HILLINGDON GARDENS

DESIGN UPDATES

GREATER LONDON AUTHORITY

Job Number: 19011
Document Revision: P4
Date of Issue: 16.06.2020
Purpose of Issue: Planning
Key Personnel: FvB
Reviewed by: RC
Review Date:

2.18. BUILDINGS 11 & 12 PLANS

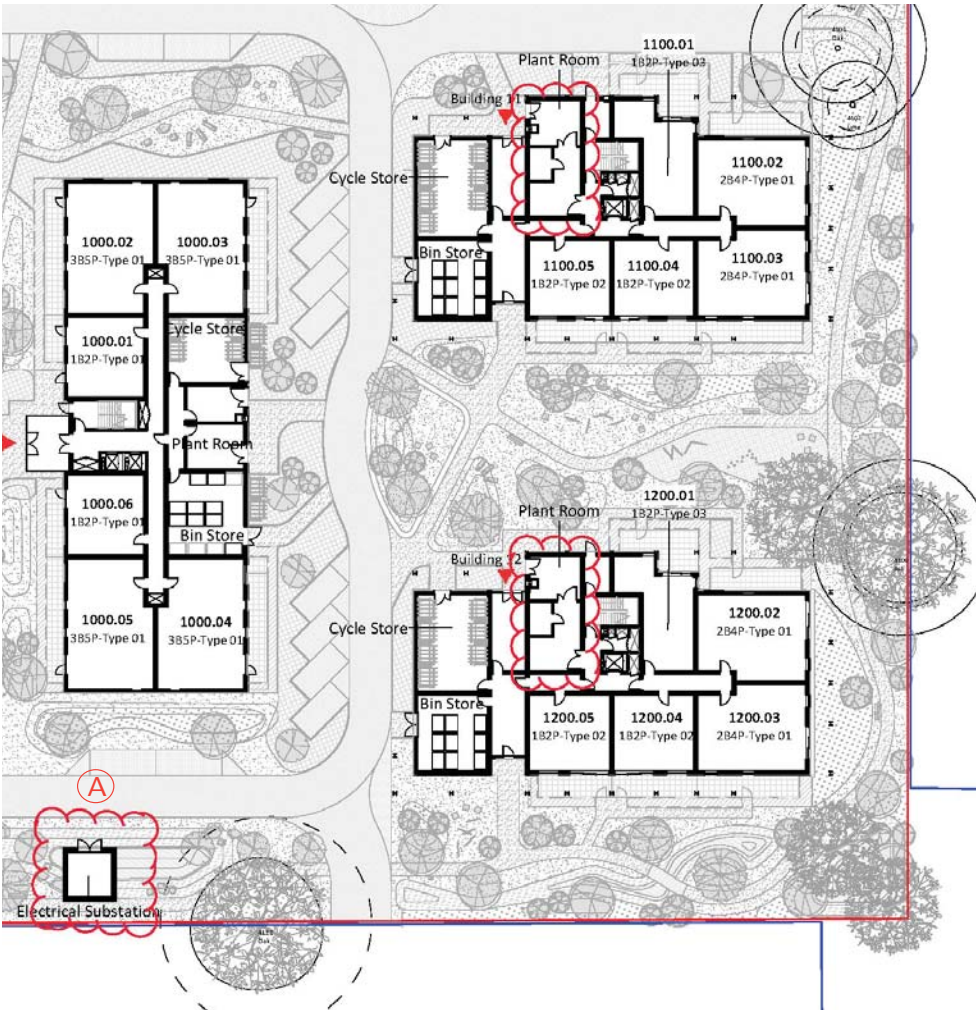
A_B12 sub-station moved externally (along site road opposite B10) to simplify structural and fire safety designs.

2.19. BUILDINGS 11 & 12 ELEVATIONS

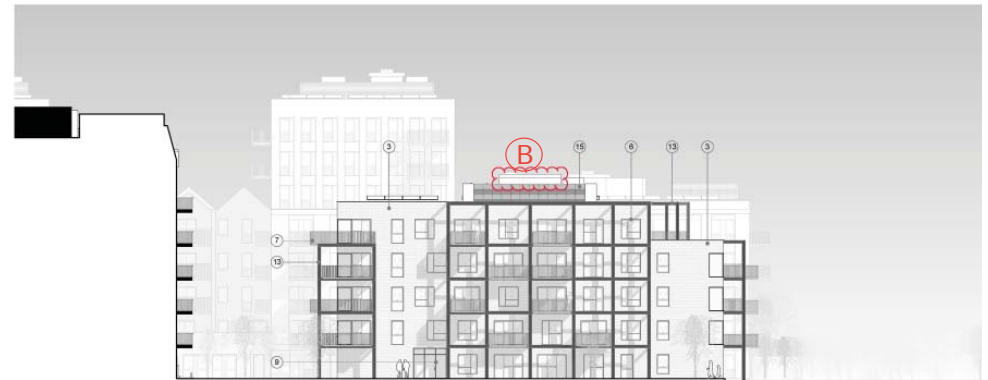
B_Permanent maintenance access from stair core added
and indicated residential plant requirements.
